STAFF REPORT: 09/10/2025 REGULAR MEETING

APPLICATION NUMBER: HDC2025-00539

ADDRESS: 1724 SEYBURN

SCOPE: REMOVE EXISTING CANOPY, ERECT NEW FRONT PORCH ROOF AND COLUMNS, ALTER REAR PORCH, ALTER DOORS/WINDOWS, OTHER REHABILITATION WORK

Front Porch Canopy/Roof Analysis

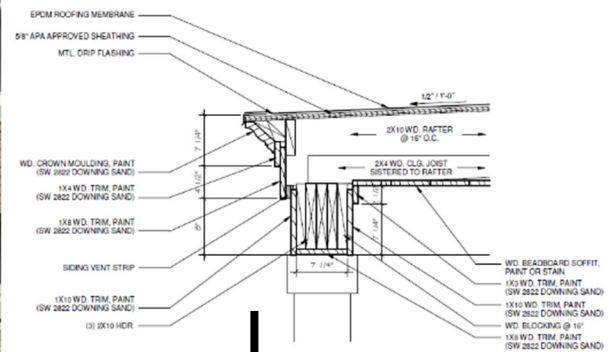
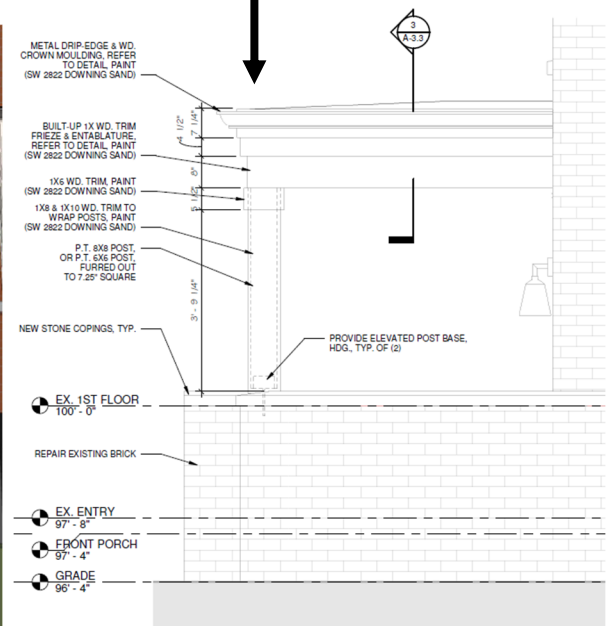
- The existing roof canopy, with its angular supports, flat roof, and minimalist design, appears to reflect a design that would be more typical of a mid-century build, contrasting with the more colonial and detailed entrance canopies of surrounding properties.

- It is typical for houses of this era and style to feature porch columns that rise from the brick wings of the front porch. The proposal reflects this architectural detail, which is also commonly seen on historic porches throughout the West Village Historic District.
- As the *Field Guide to American Houses* by Virginia Savage McAlester states about Colonial Revival front entrances: "Accentuated front door, normally with decorative crown supported by pilasters, or extended forward and supported by slender columns to form entry porch."

- Considering the existing porch canopy is likely not original, it is staff's opinion that the massing, style, and materiality of the proposed front porch canopy/roof is appropriate.

Door & Window Analysis

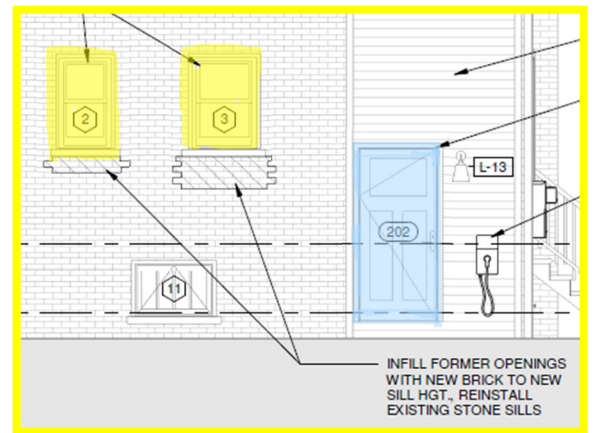
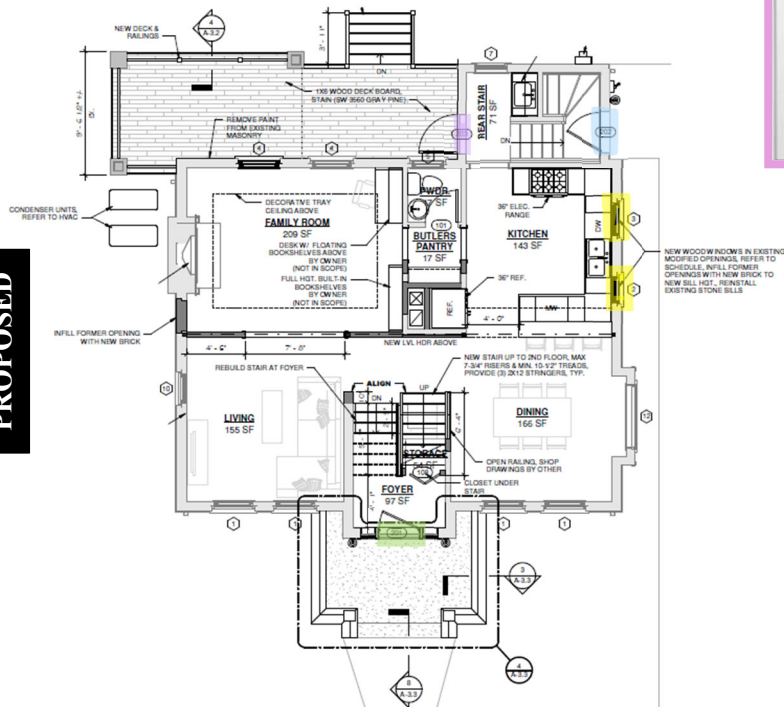
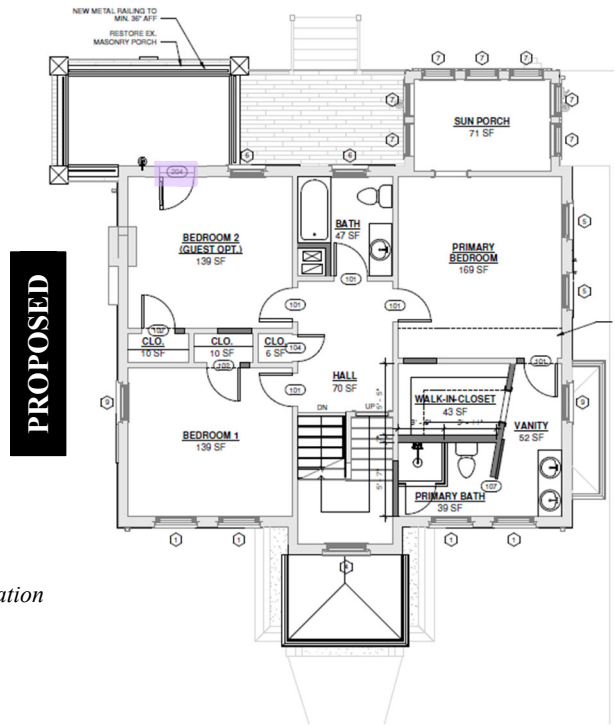
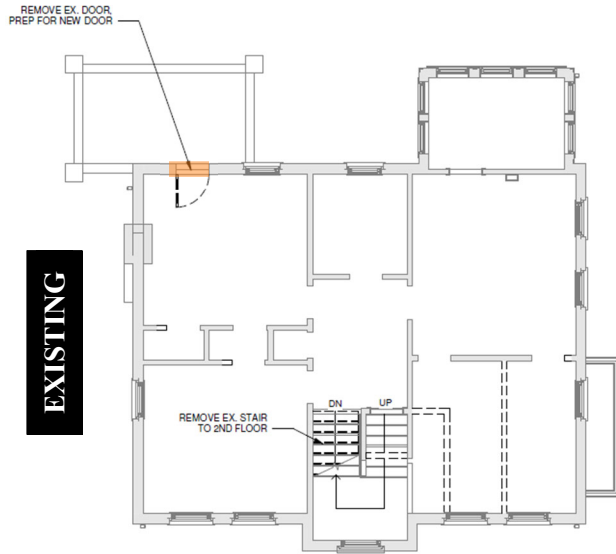
- In areas where infill brick is proposed, a mix of Interstate Brick in the Walnut and Bronzestone colorways will be used. This infill brick combination was already previously approved for masonry repairs with HDC2025-00443.

Rear Porch Rebuild and Extension Analysis

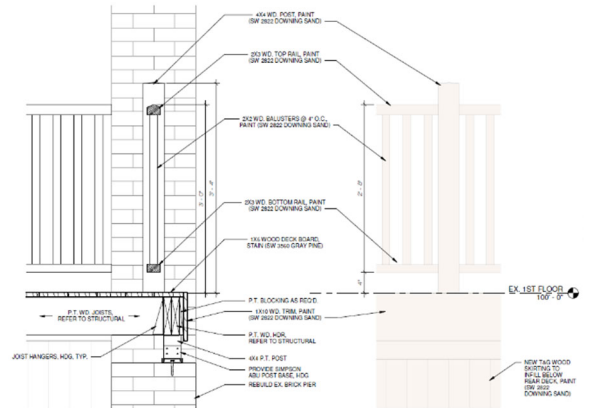
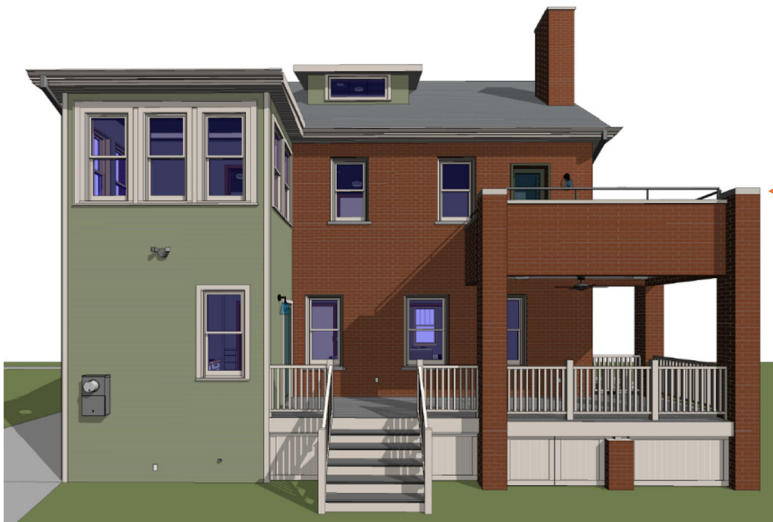
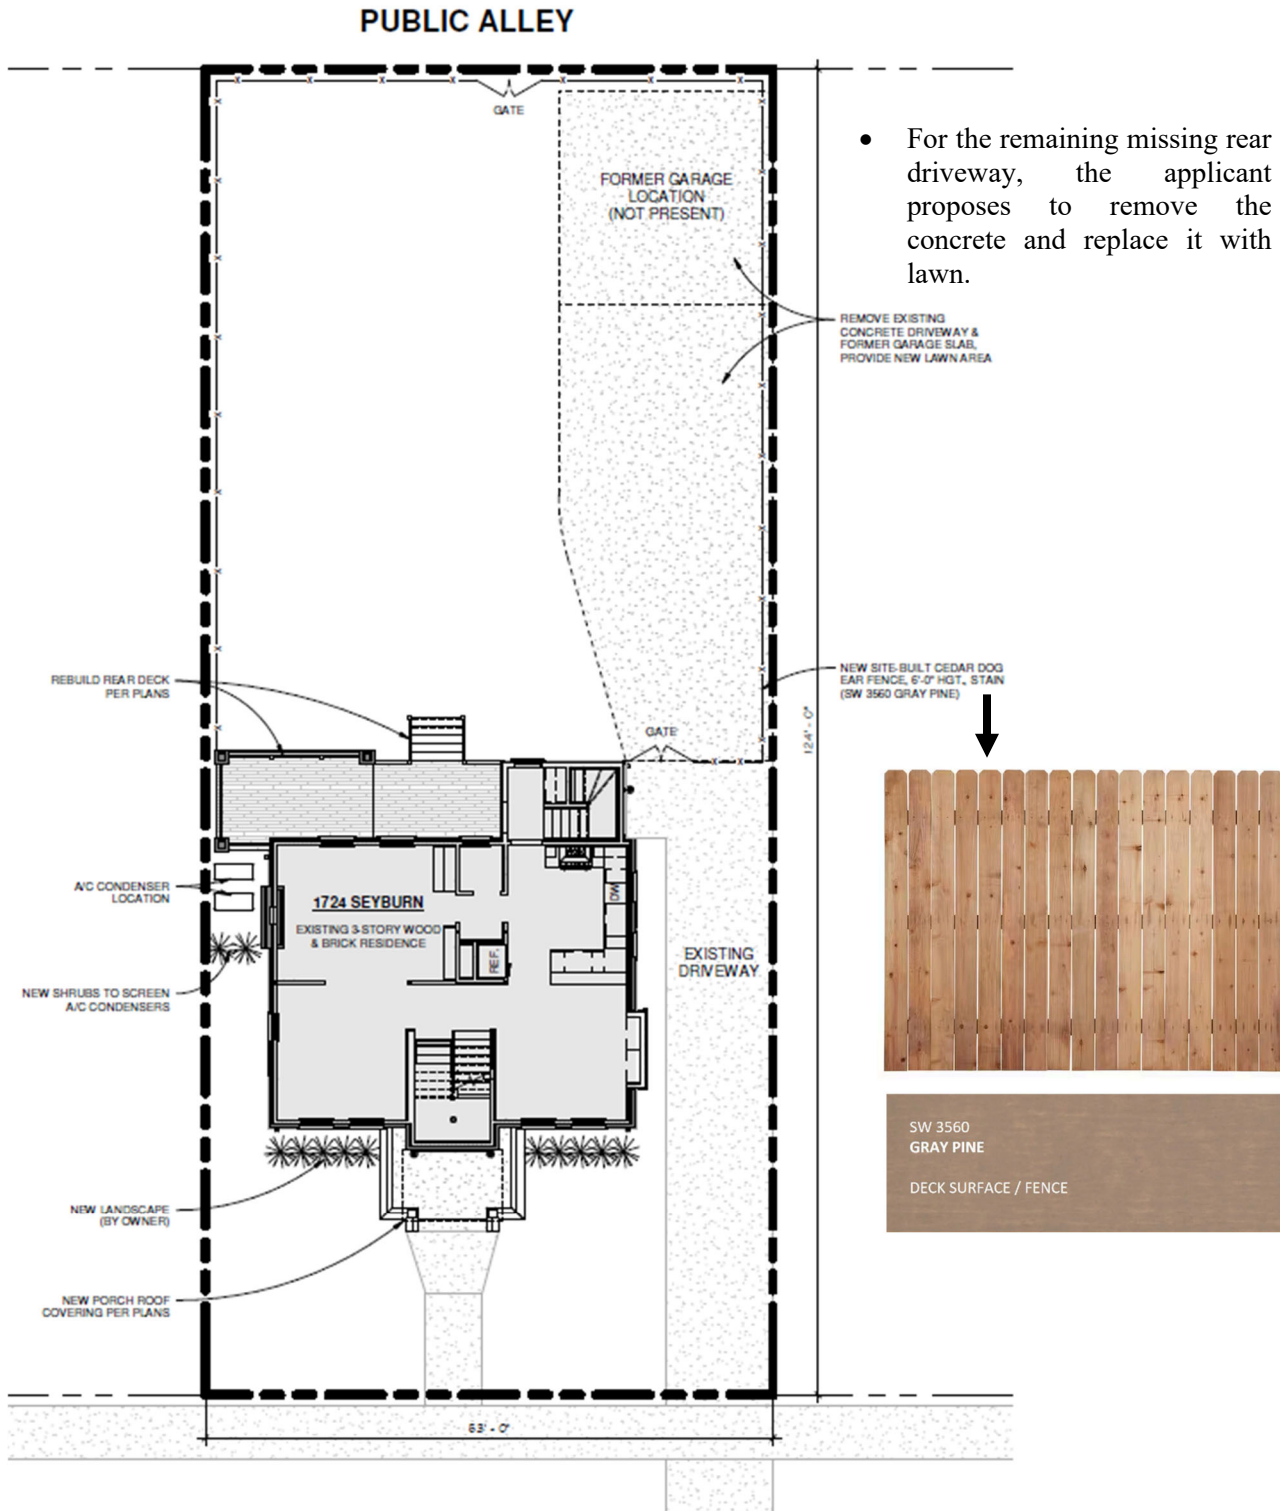
- The applicant states that “the rear masonry porch has failed at its concrete slab.”

- Staff finds the proposed scope of work for the rear porch to be appropriate but would like to note that the second level of the existing porch does not appear to be historic. The 1915 Sanborn map, as shown on page 2 of this report, and a 1951 Sanborn map indicate that the rear porch was historically only one level.

Paint and Stain Analysis

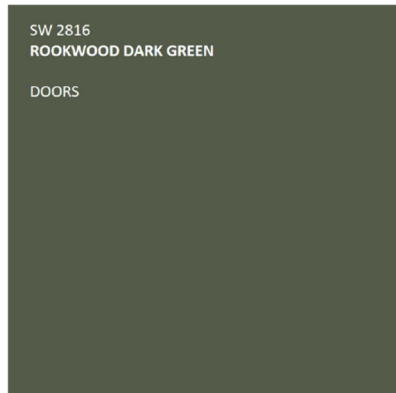
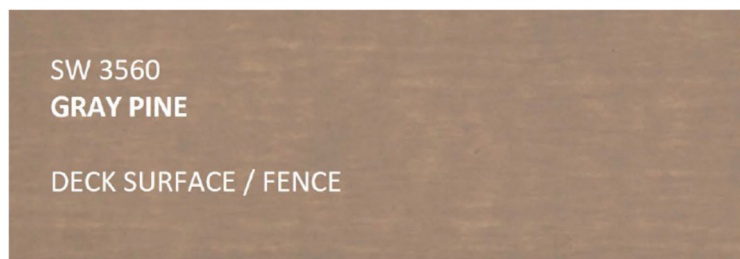
- The proposed colors generally follow the Historic District Commission's Color System E.
- The application proposes to re-paint the window sills. Since limestone window sills were historically not painted, it is staff's opinion that the existing paint should be removed.

- Painting the limestone window sills is not historically appropriate.

- Window sills are to have the existing paint removed, in a manner acceptable by staff, and are not to be repainted.
